C2PC Request Letter

Class II permissive change for **FCC ID: DD4AD1G57**

Applicant: Shure Incorporated

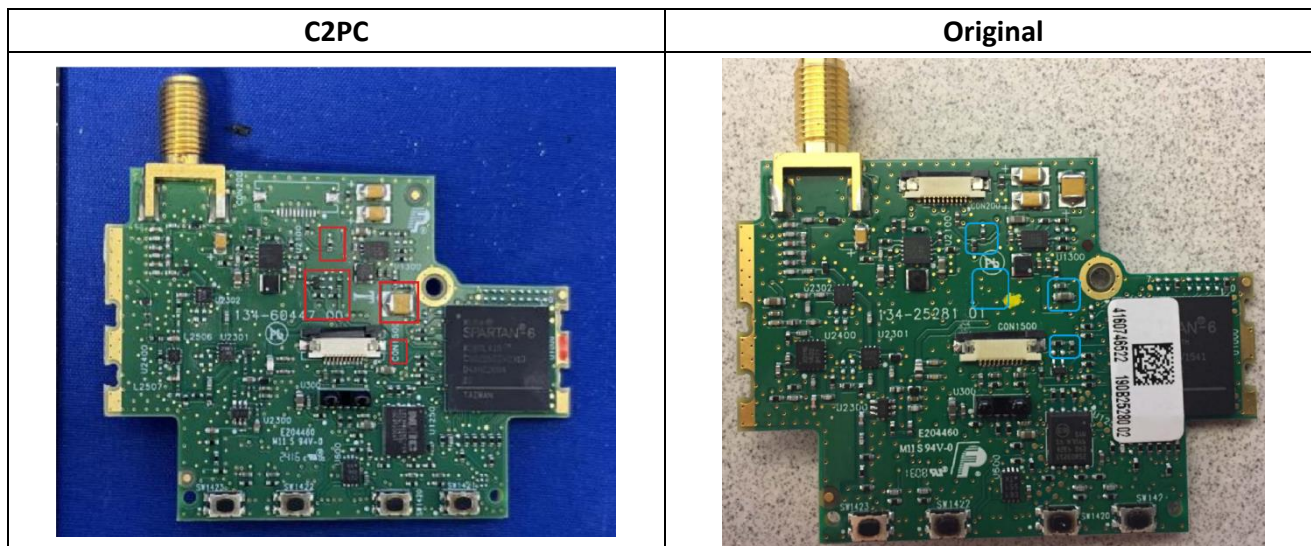
In addition, the difference identified in the picture below between the AD1 C2PC PCB and AD1 Original PCB photos show an update to support the Microprocessor functionality. The component location and updates were changed so that the Microprocessor can operate efficiently and did not include any components related to the RF signal path of the AD1.
